MCB Issue List for APR1400 Section 5.4.2.1

Figure-1. Before and After Installation of Eggcrate Flow Distribution Plate

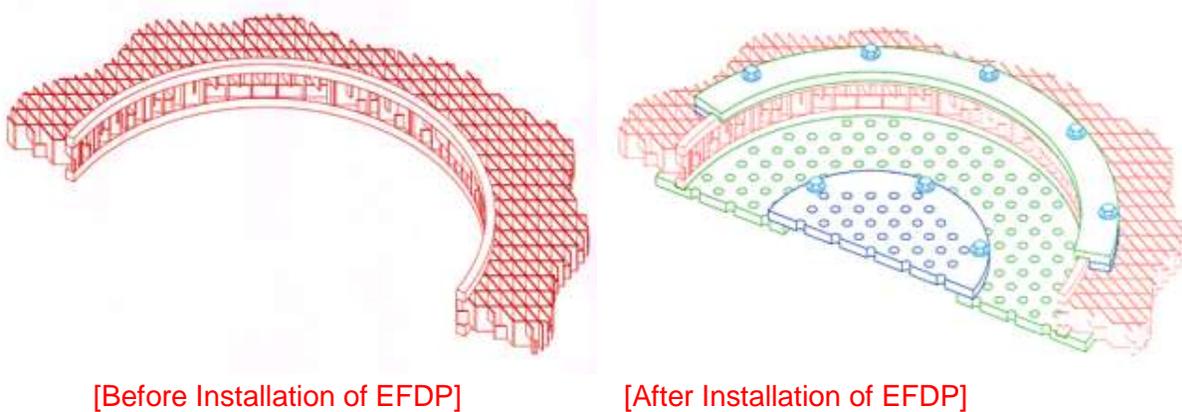
The discussion of tube supports in FSAR Subsection 5.4.2.1.2.2 states that this design has been proven to reduce wear in operating reactors.

Revise FSAR Subsection 5.4.2.1.2.2 to provide additional justification for the assertion. If it is based on operating experience outside the United States, provide information on this foreign operating experience to facilitate the staff's review.

Eggcrate flow distribution plate (EFDP) has been adopted to mitigate the concentrated flow into the central cavity region so as to reduce the localized wear. Up until Han-bit NPP Units 5&6 (OPR1000), there had been no EFDP. Han-ul NPP Units 5&6 (OPR1000) is the first of a kind steam generator to be equipped with the EFDP.

Figure-1 shows the schematics before and after the installation of EFDP.

Comparison of tube wear status at U-bend region between those NPPs provides an additional justification how the EFDP design reduces the tube wear at the central cavity region effectively. Tables 1 & 2 summarize the tube wear status (number of indications and number of tubes with indications) at U-bend region of Han-bit Units 5&6 and Han-ul Units 5&6 based on the recent eddy current test (ECT) results performed during their 6th in-service inspection (ISI).

[Downcomer Feedwater Ring]

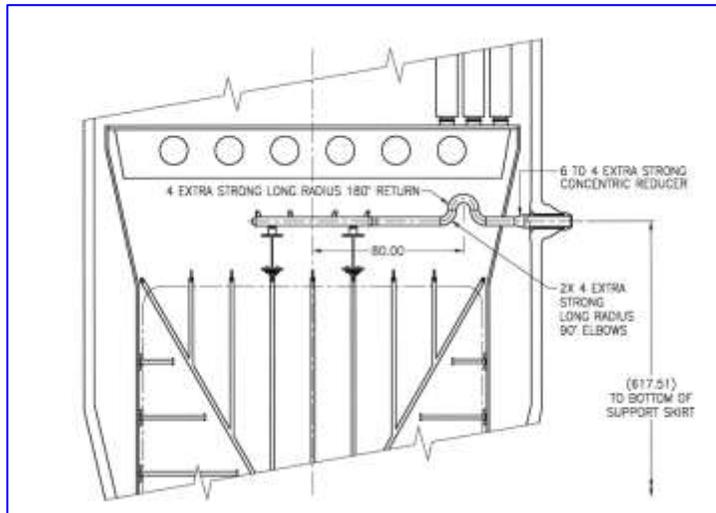
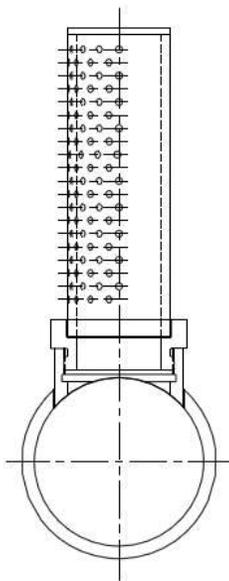
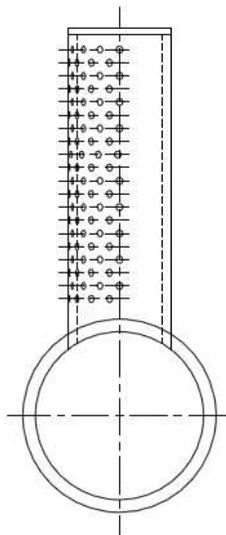
Revise FSAR Subsection 5.4.2.1.6 to explain the difference between downcomer feedwater and recirculation feedwater rings, and provide the location of the feedwater box.

The downcomer feedwater ring inside the steam generator applies the upward bend using a goose-neck design and I-type spray nozzles having small holes (hole diameter is 0.23 inch) and are installed to prevent the foreign object inclusion. Two I-type spray nozzles at each end of the piping is threaded into the piping, thus the two I-type spray nozzles can be detached from the piping to remove any foreign objects.

The recirculation feedwater ring provides the circulation of water through the steam generator during wet lay-up and the addition of chemical cleaning agents. There are J-type discharge nozzles on the recirculation piping.

ELEVATION

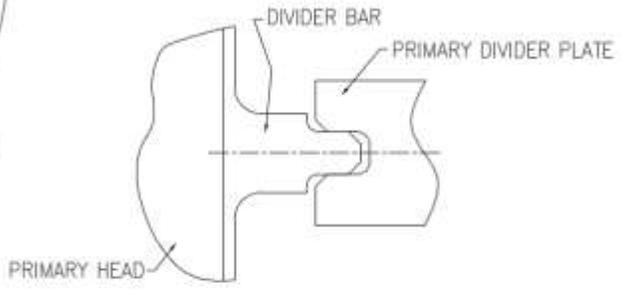
FSAR Table 5.4.2-2 identifies SA240, Type 410S martensitic stainless steel as the divider plate material for the steam generators. If the divider plate provides structural support to pressure boundary components (e.g., tubesheet), then the FSAR needs to provide the fabrication and processing requirements.

If the divider plate provides structural support, revise FSAR Table 5.4.2-2 to include fabrication and processing requirements for SA240, Type 410S martensitic stainless steel, or include a reference to a section in which such requirements are addressed.

The divider plate in the steam generator primary head applies the tongue-and-groove joint instead of welding to the primary head and tubesheet as shown below. The divider plate is not the structural support to the pressure boundary components.
